SUBJECT: Inner Harbor Navigation Canal, Lake Borgne Basin – Design Criteria Waiver for the
Resiliency Design Checks

MEMORANDUM FOR RECORD

SUBJECT: Inner Harbor Navigation Canal, Lake Borgne Basin – Design Criteria Waiver for the Resiliency Design Checks

Fig 3: Surge level frequency curve for future conditions (2060) for Lake Borgne area with 10% and 90% confidence levels.

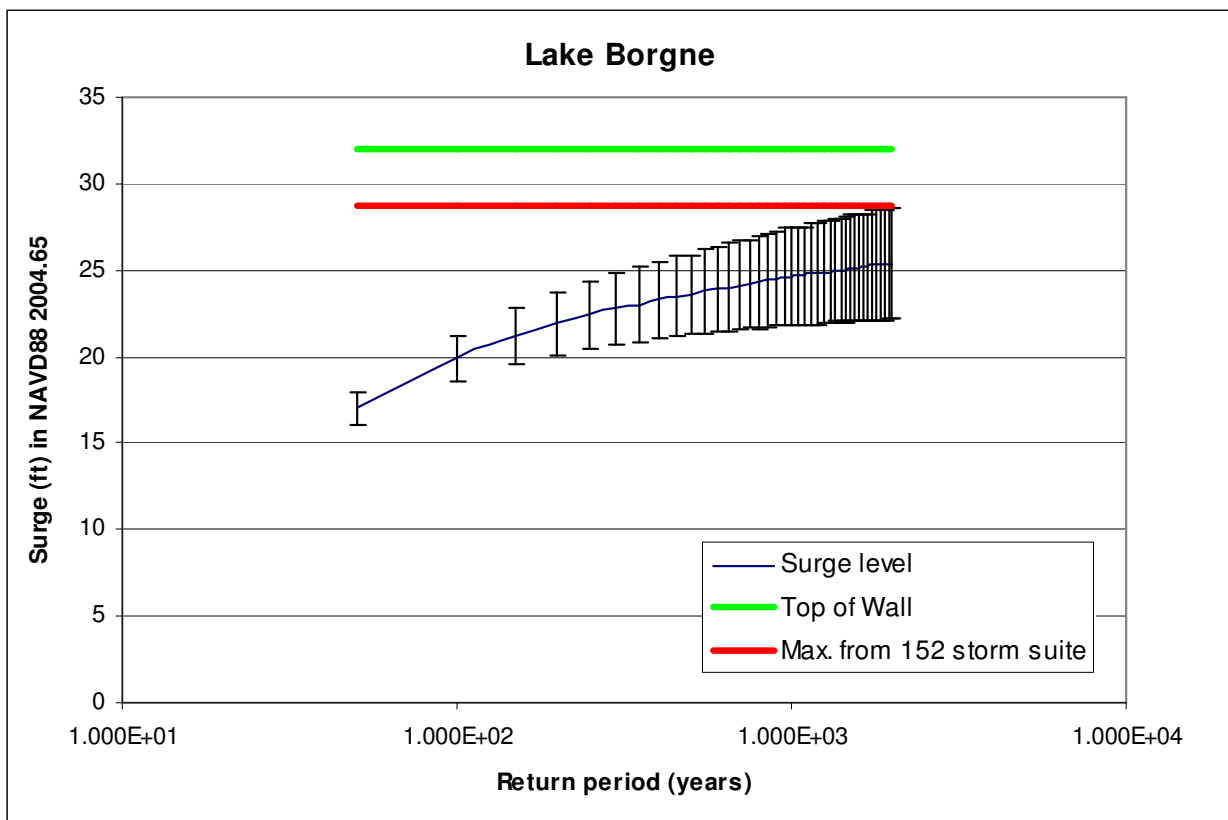
The basis for the first argument is shown in Figure 3 below. It can be observed the return period that is associated with the surge level to the top of the wall is much larger than 2000 years. Although the probabilistic method is not applicable for this range, a 10,000 year return period seems reasonable for surge levels equivalent to the top of wall based on extrapolation.

Fig 4: Schematic diagram with the existing checks (left) and proposed checks (right) in the Structural and Geotechnical Design Checks load cases – for Lake Borgne area.

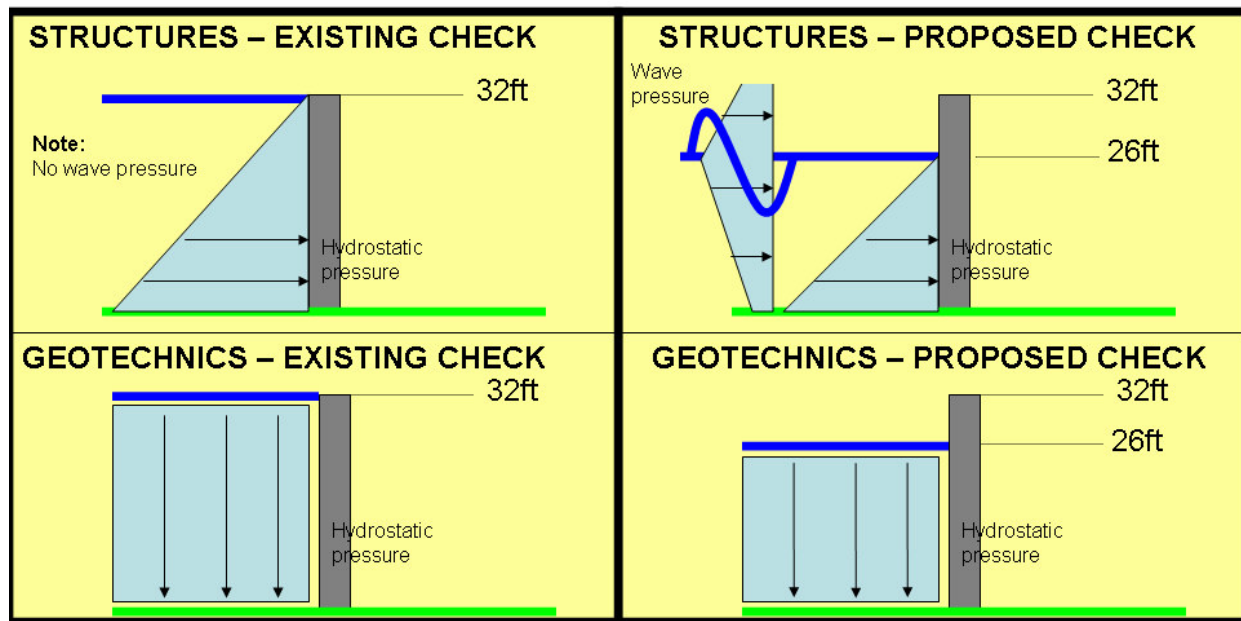
5. Recommendations - We recommend modifying the Structural Design Check as follows. We propose to change the top of wall surge levels to the 0.2% surge levels in order to attach a reasonable return period to the Design Checks event. For structures, we also propose to include wave loading into the Design Check. For both surge and wave loadings, we propose to use 90% confidence levels which is consistent with the basic 1% design loadings. The allowable overstress and factors of safety for the pile loads are kept equivalent to the existing Design Check Case III. This results in the following recommended structural design check (i.e. replacing the three design checks with top of wall):

Along the same lines, we recommend modifying the Geotechnical Design Check as follows. We propose to change the top of wall surge levels to the 0.2% surge levels in order to attach a reasonable return period to the Design Checks event. We propose to use 90% confidence level which is consistent with the basic 1% design loadings. This results in the following recommended geotechnical design check (i.e. replacing the design checks with water to the top of wall):

Load Case Name	Loads Included	Allowable Overstress ²	Pile Load - Factors of Safety ²
Resiliency with Wave (SWL ¹ +UNBL+Wave+Wind+BI)	Dead Load, SWL ¹ , Unbalanced Load ⁴ , Wave Load ³ , Wind Load ⁴ , and Barge Impact Load ⁴	67%	1.2

Analysis Condition	Required Minimum Factor of Safety	
	Spencer Method ¹	MOP ²
End of Construction ³	N/A	N/A
Design Hurricane ⁴ (SWL)*	1.5	1.3
Water at Project Grade (levees) ⁵	1.4 (1.5) ⁶	1.2
Water at Construction Grade (levees) ⁵	1.2	N/A
Extreme Hurricane (SWL**) ⁵	1.3 (1.4) ⁶	1.1
Extreme Hurricane (SWL**) ^{5a}	1.3 (1.4) ⁶	1.1
Low Water (hurricane condition) ⁷	1.4	1.3
Low Water (non-hurricane condition) ⁸ S-case	1.4	1.3
Water at Project Grade Utility Crossing ⁹	1.5(1.4)	1.3 (1.2)
